PERMITTED DESIGN

PERMIT REVISION

LEVEL 2

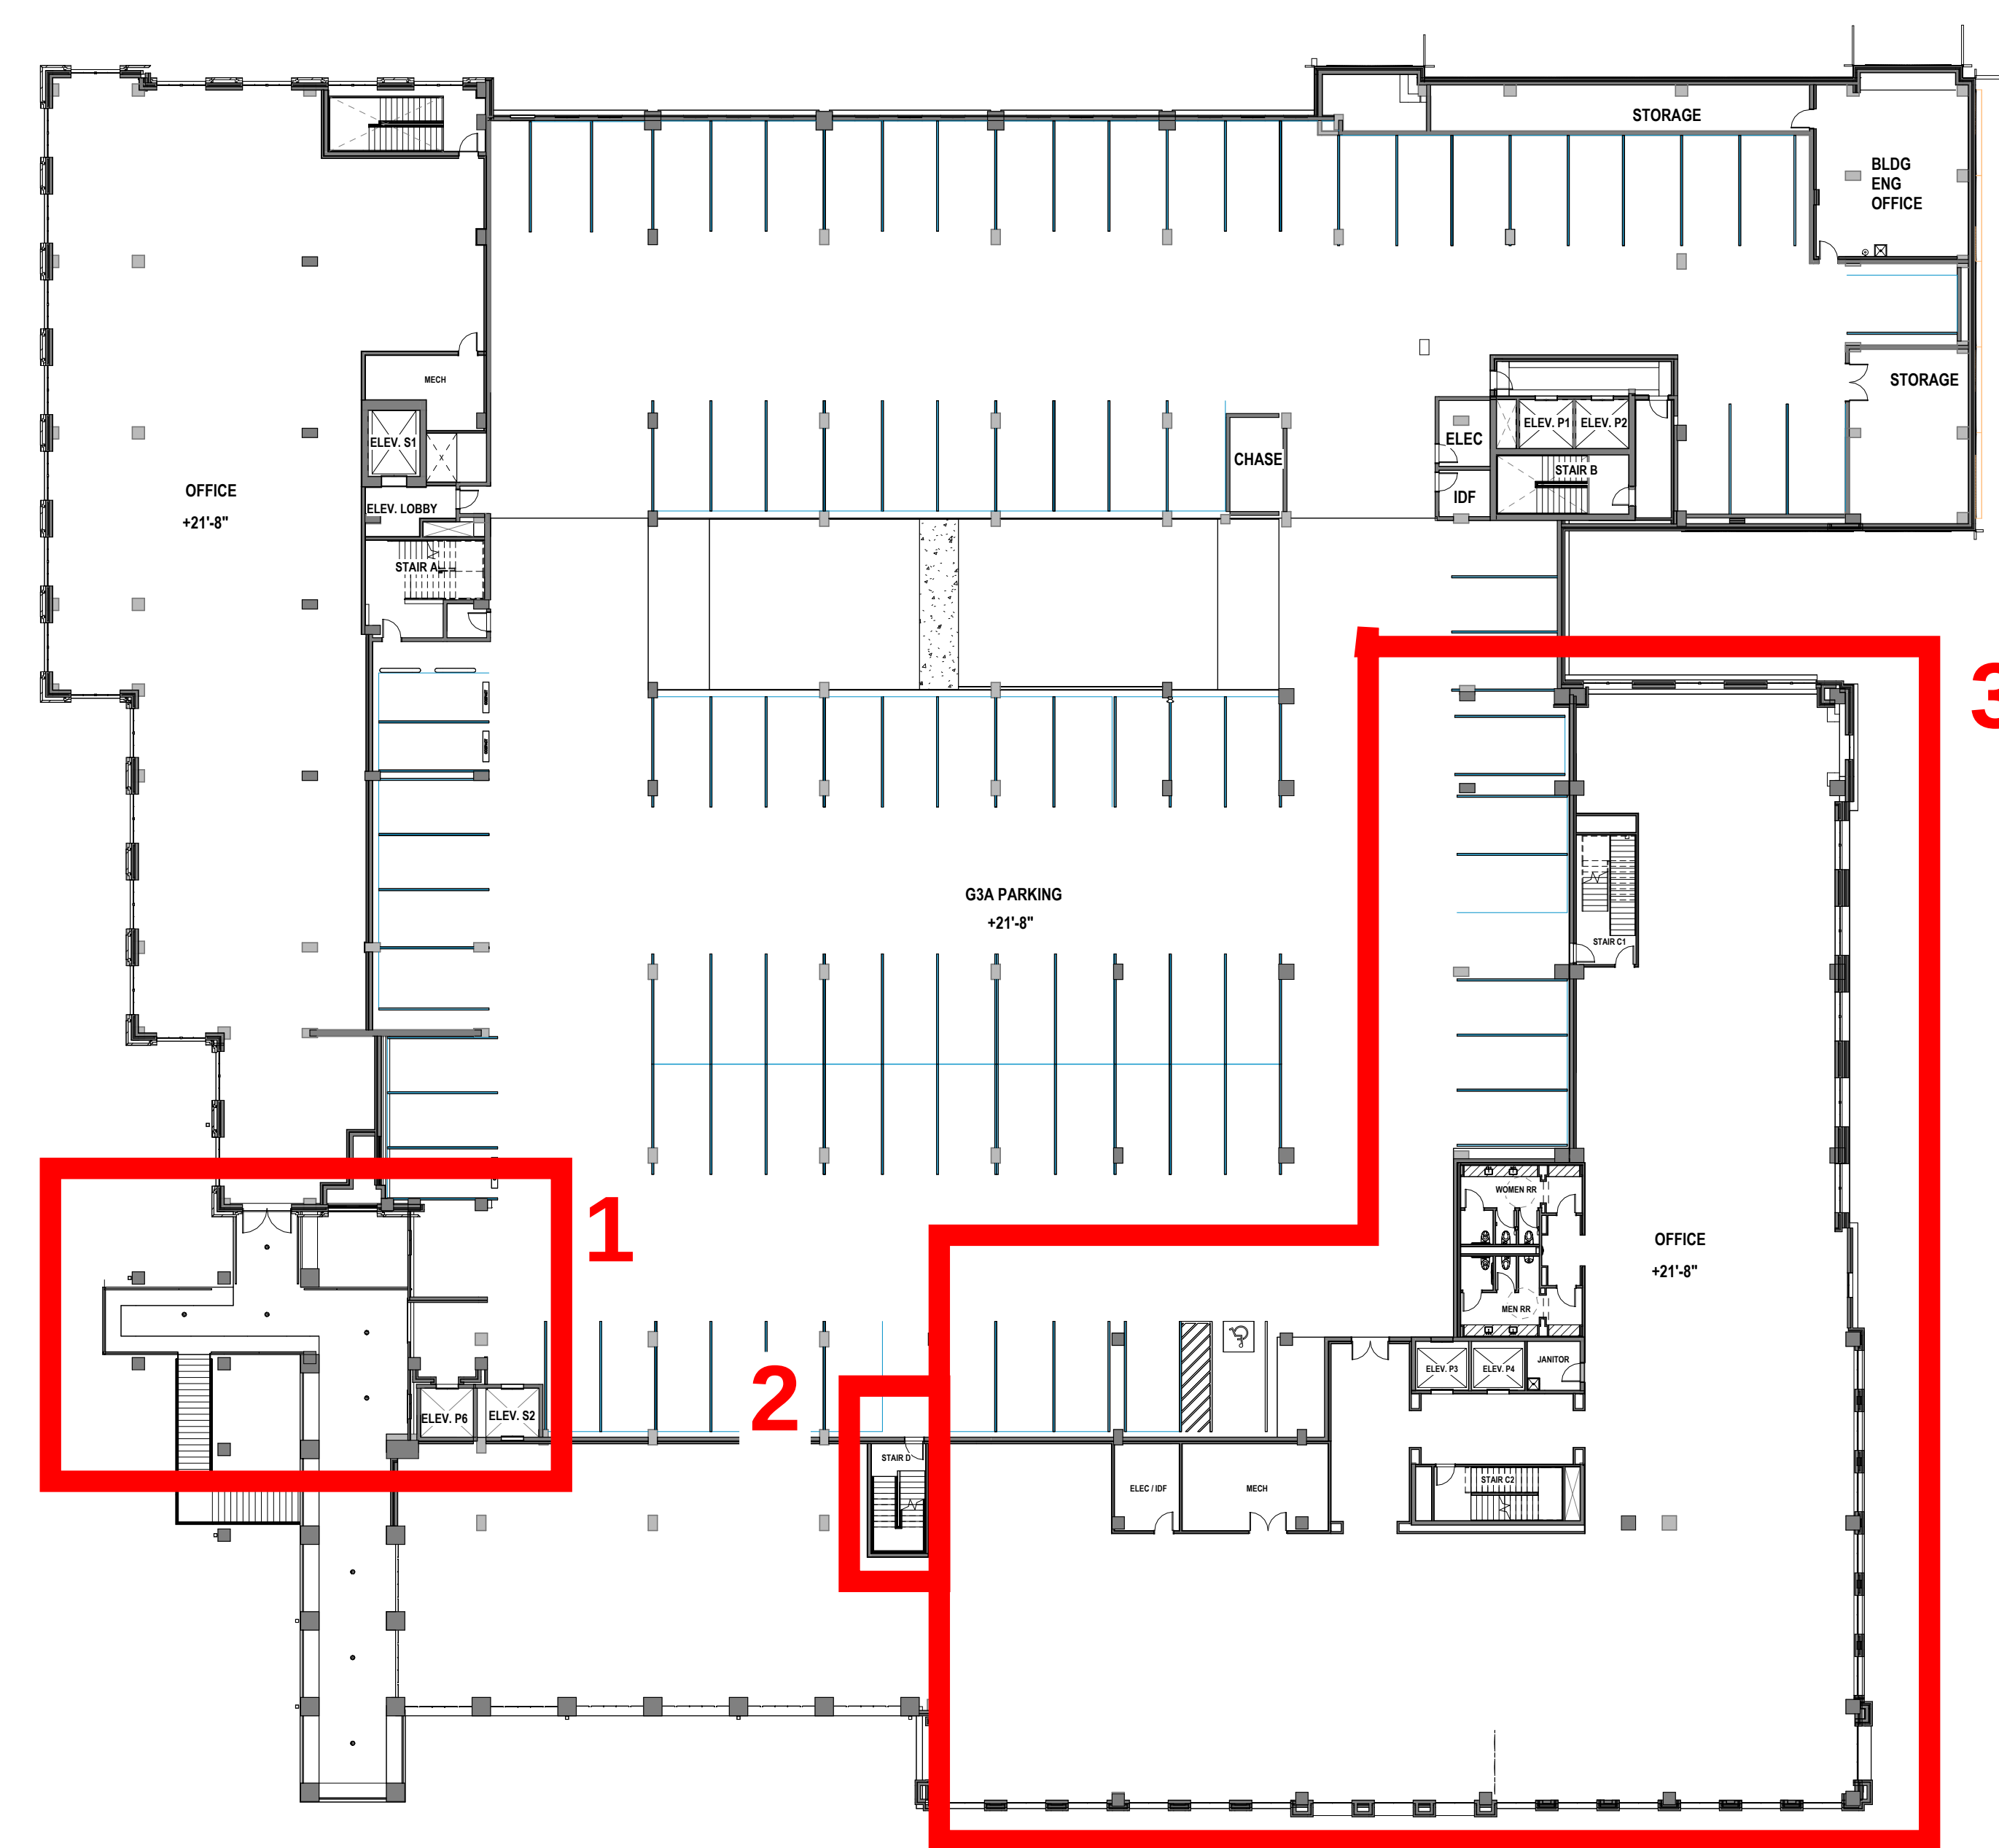
REVISIONS:

1. Reconfigured elevators. Removed (1) elevator.
2. Amenity level stair exit location moved. Removed (1) elevator.
3. Changed townhomes into retail. Removed private garages.
Rearranged elevator and stair core to accommodate office building.
Added an egress stair for office. Removed private garages.
4. Removed Level 2 of residential lobby. Added trellis at Level 1 at garage entry.

LEVEL 4

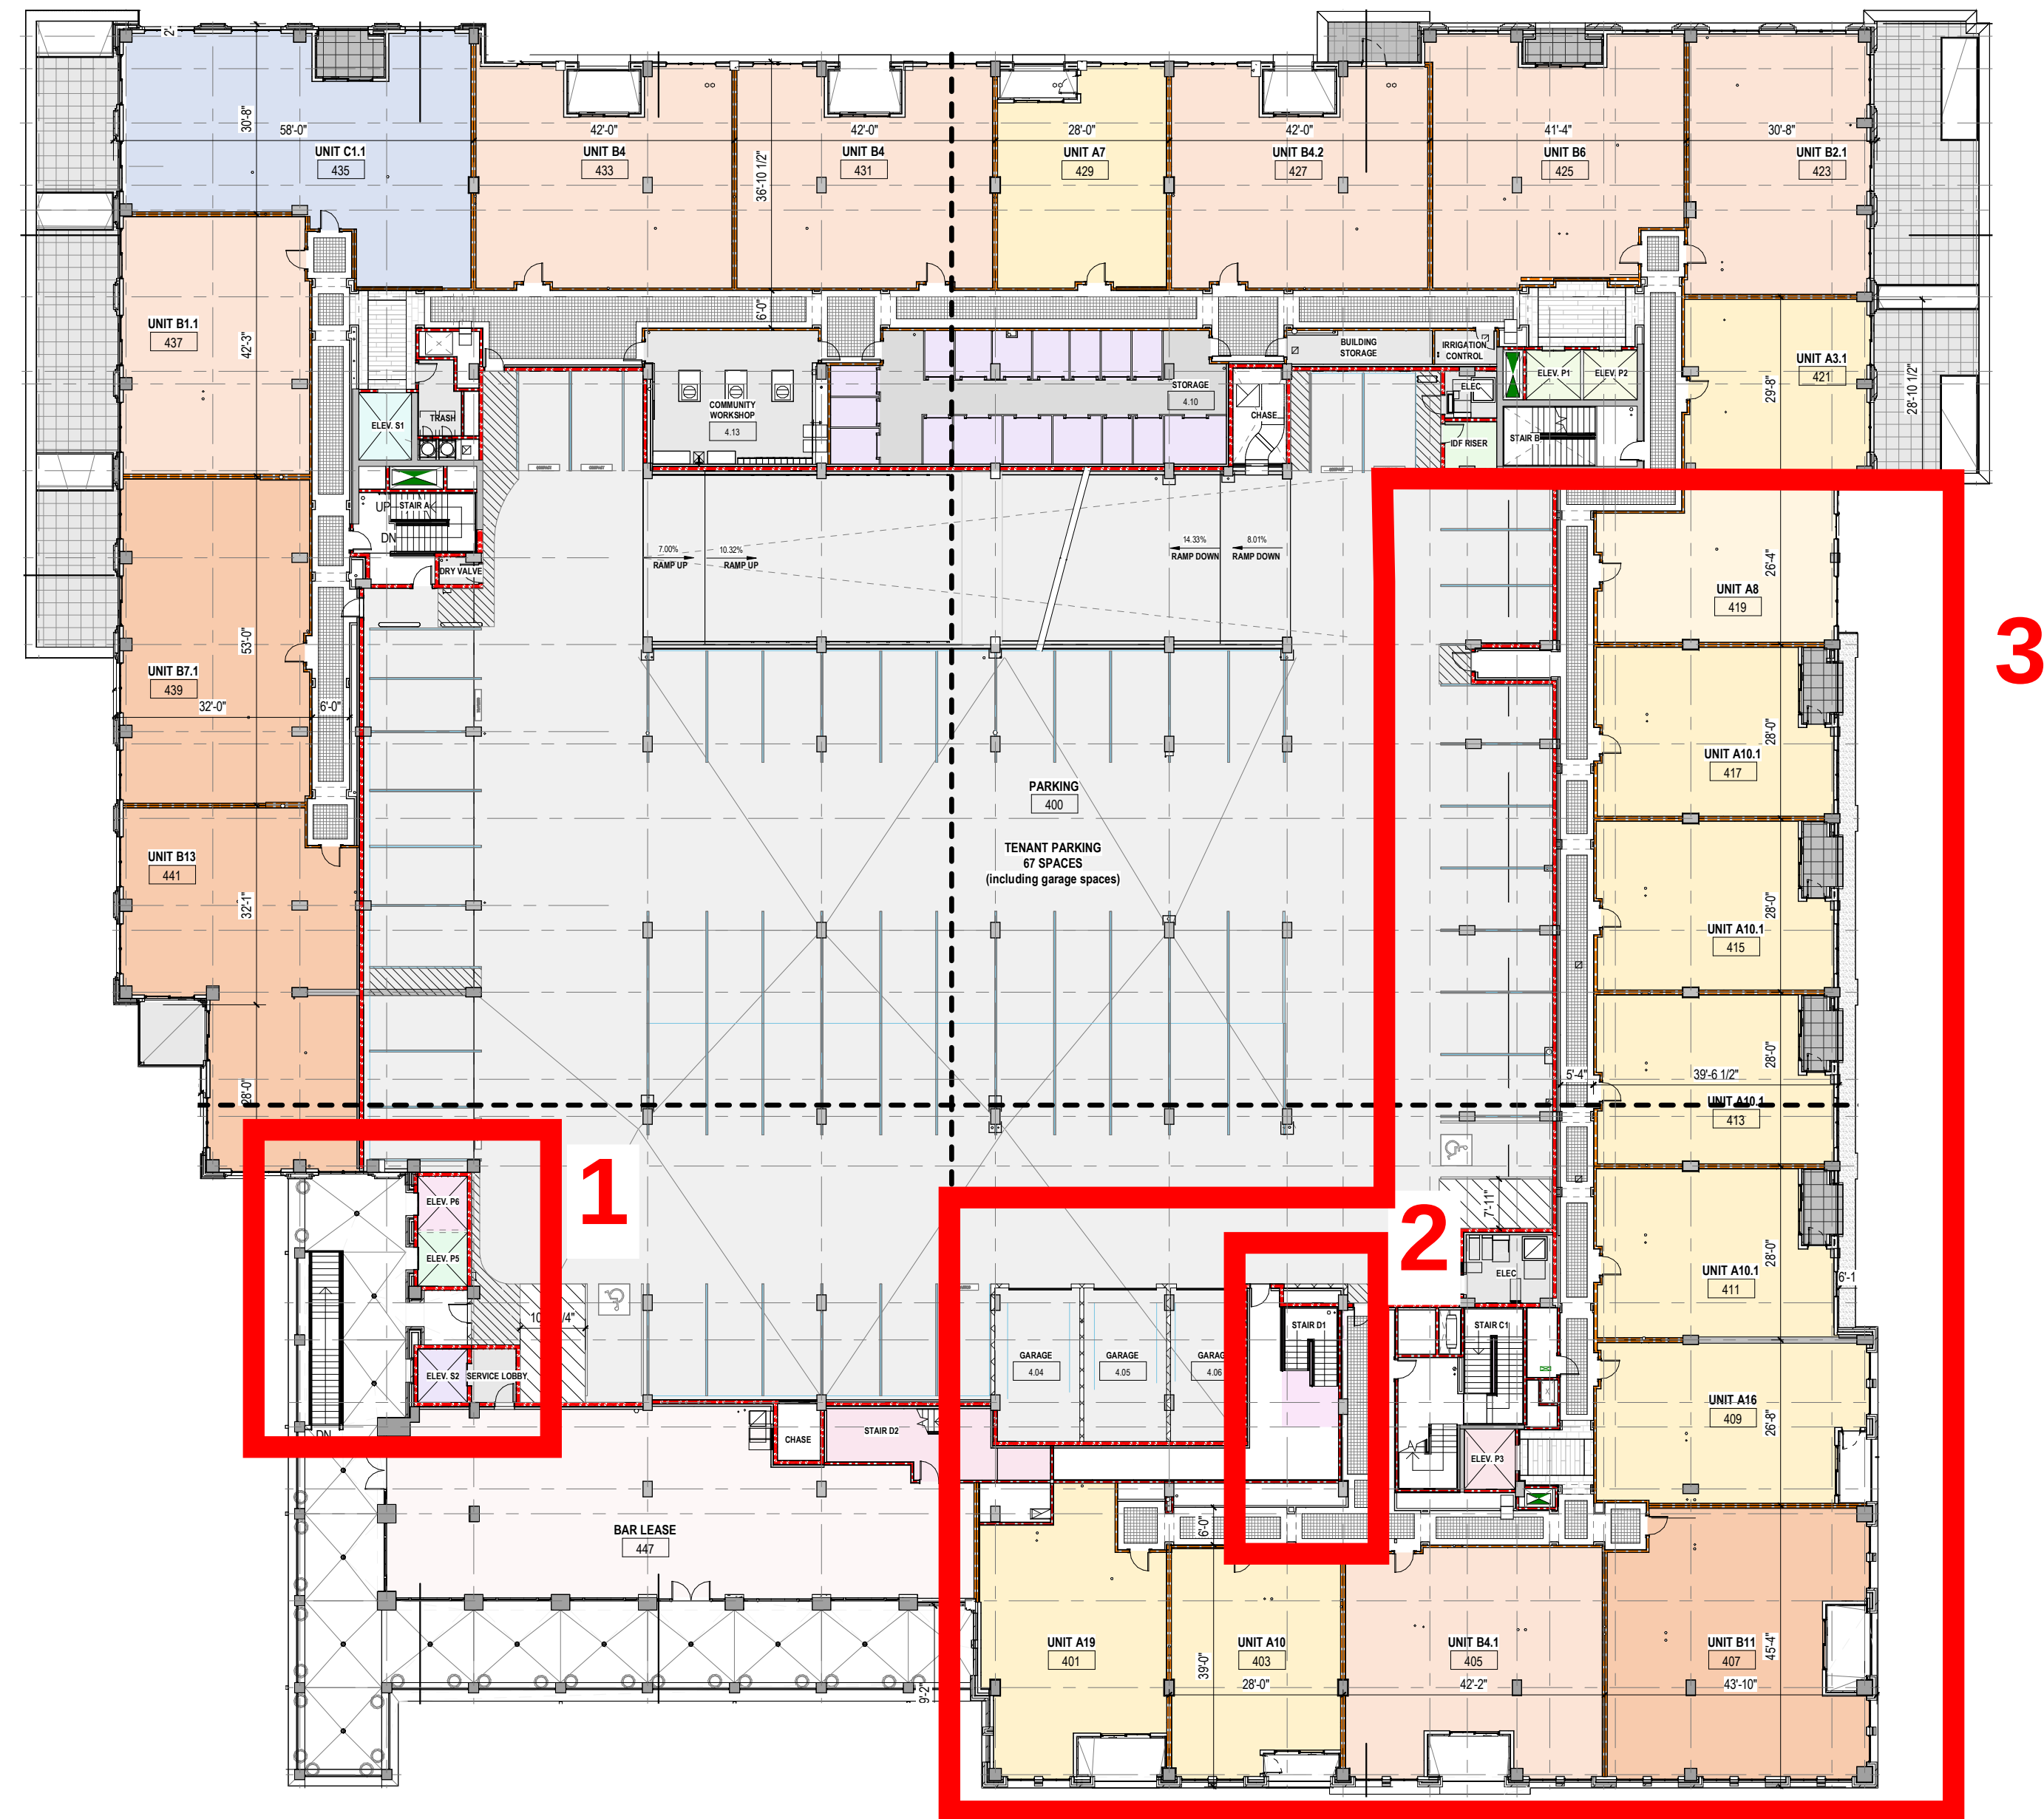
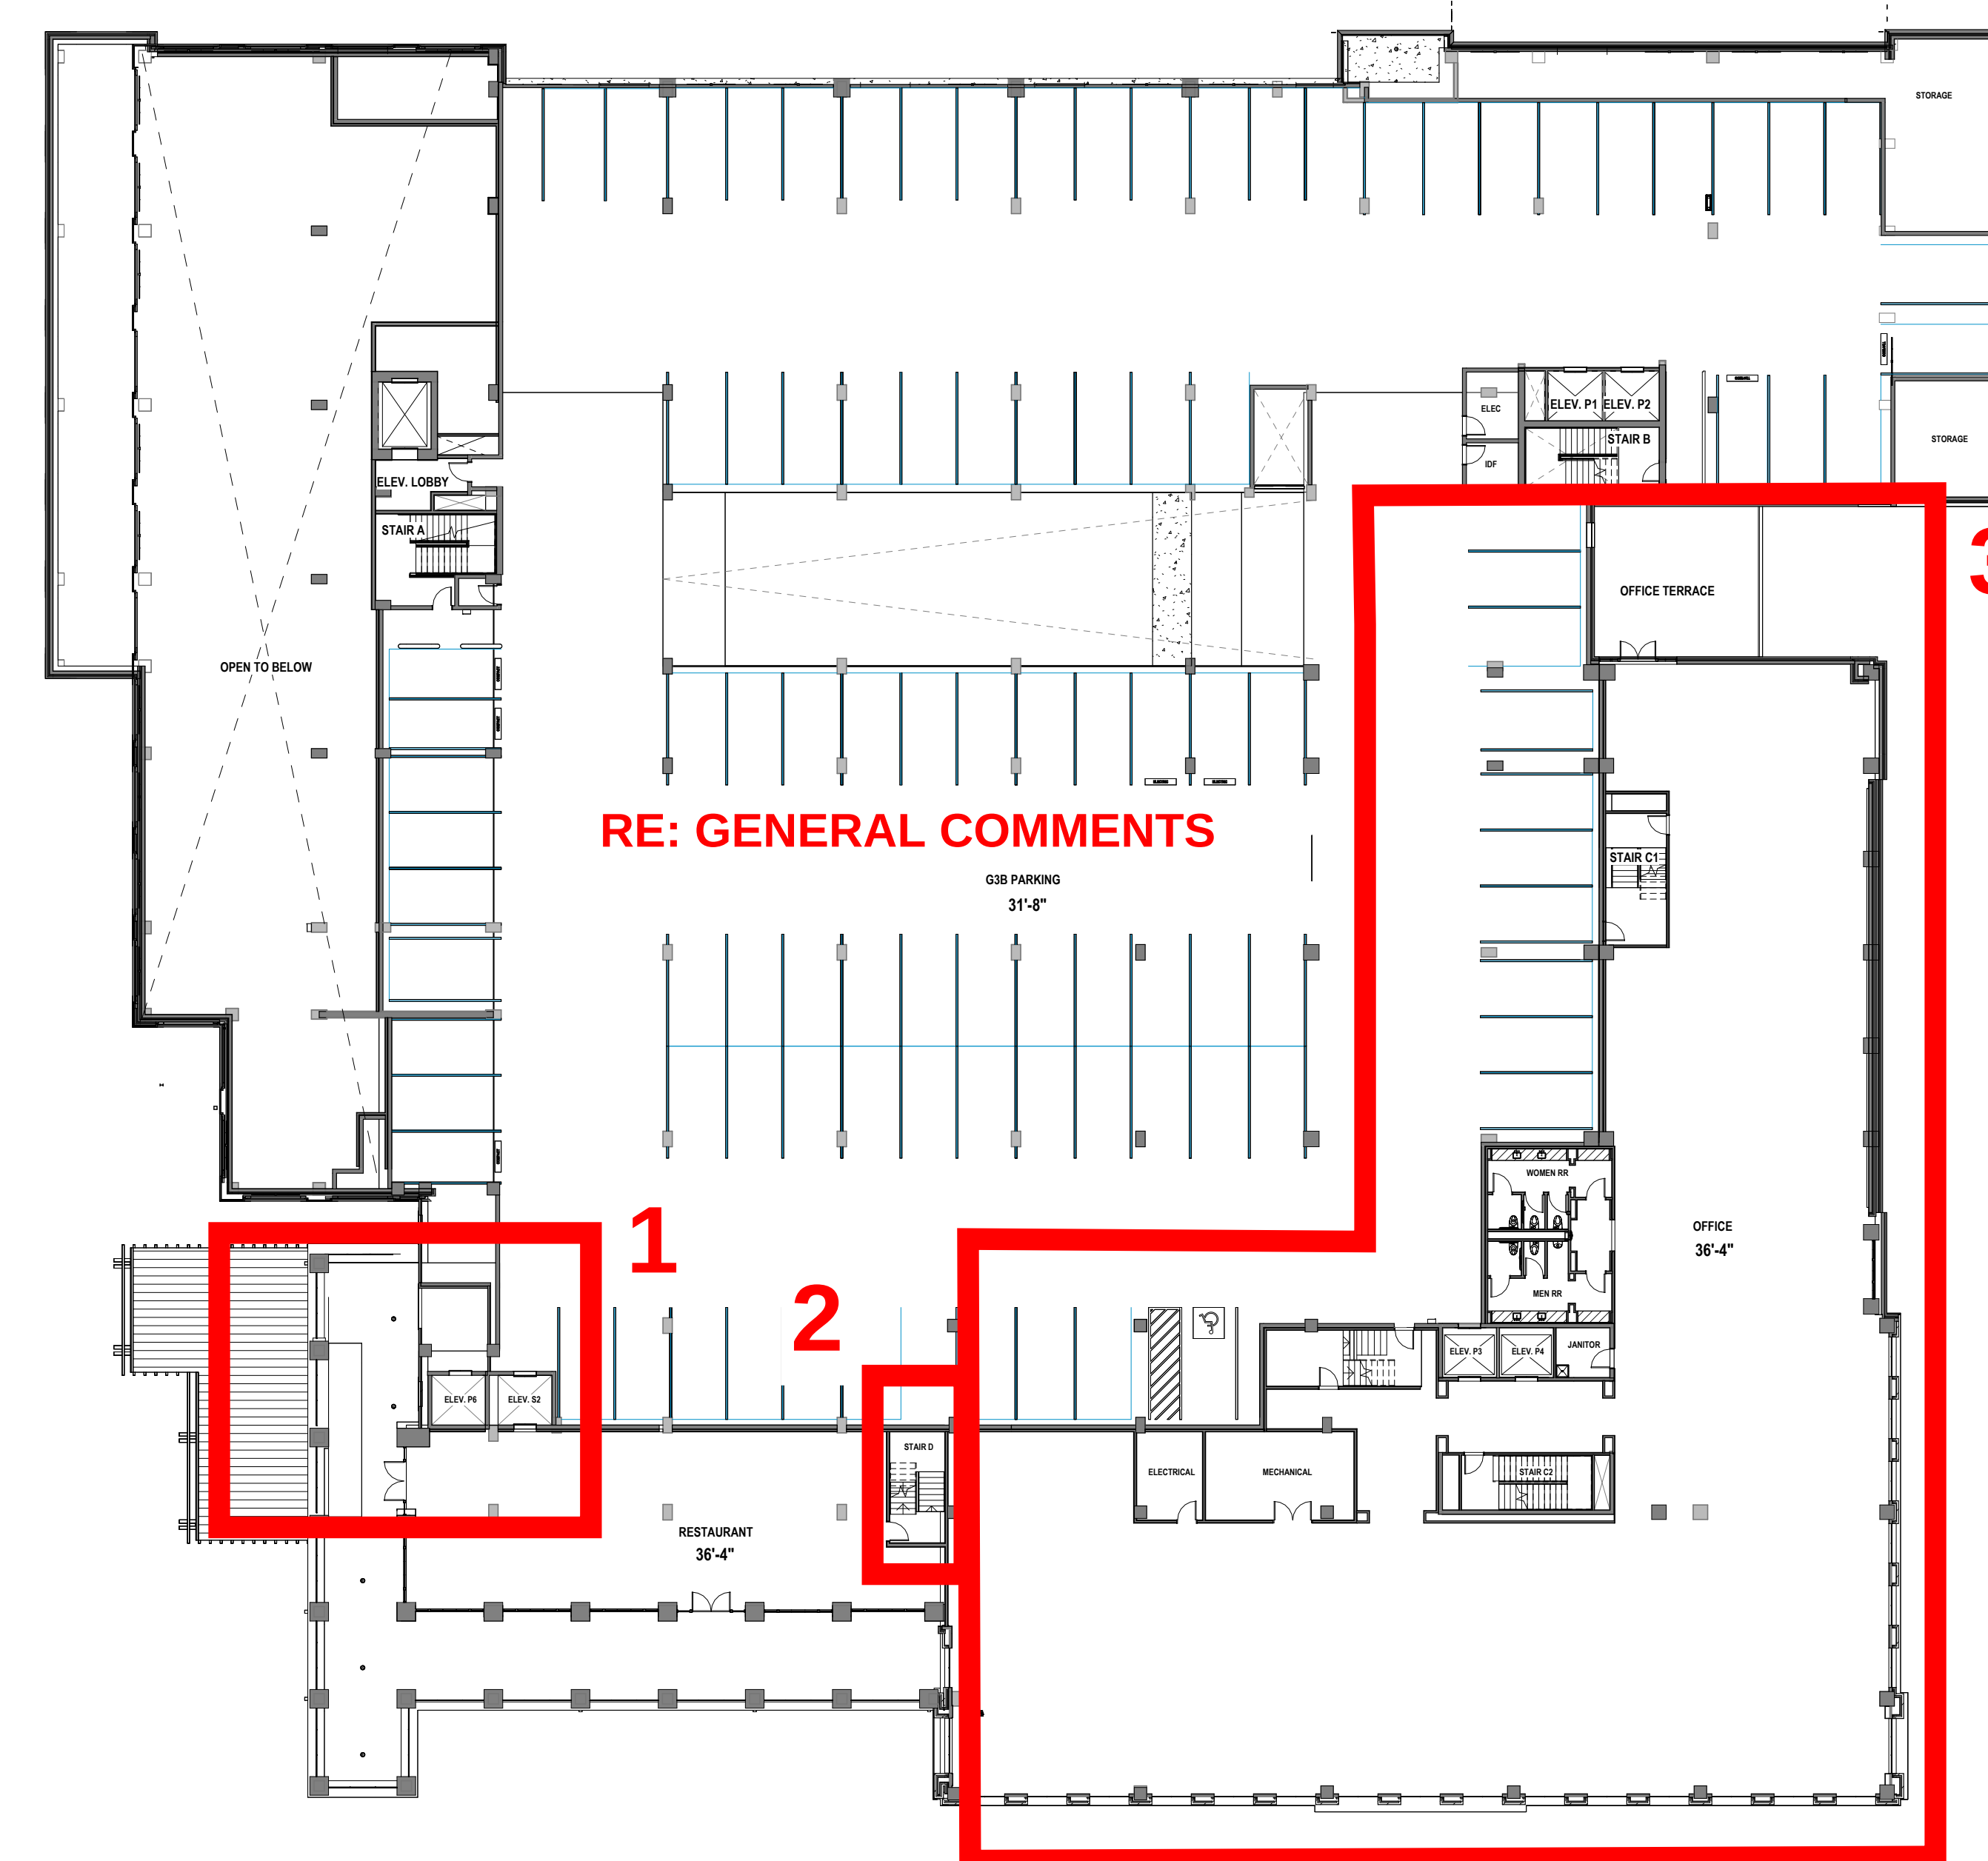
REVISIONS:

1. Reconfigured elevators. Removed (1) elevator.
2. Amenity level stair exit location moved.
3. Changed apartment units into office with dedicated office core (elevators, stairs, bathrooms, mechanical, and electrical). Added office terrace. Removed private garages.

General Comments:

- Level G3B (parking) was added between Level 3 and Level 4.
- Residential and office is split between Level C4/ G3B and Level R4/G4/
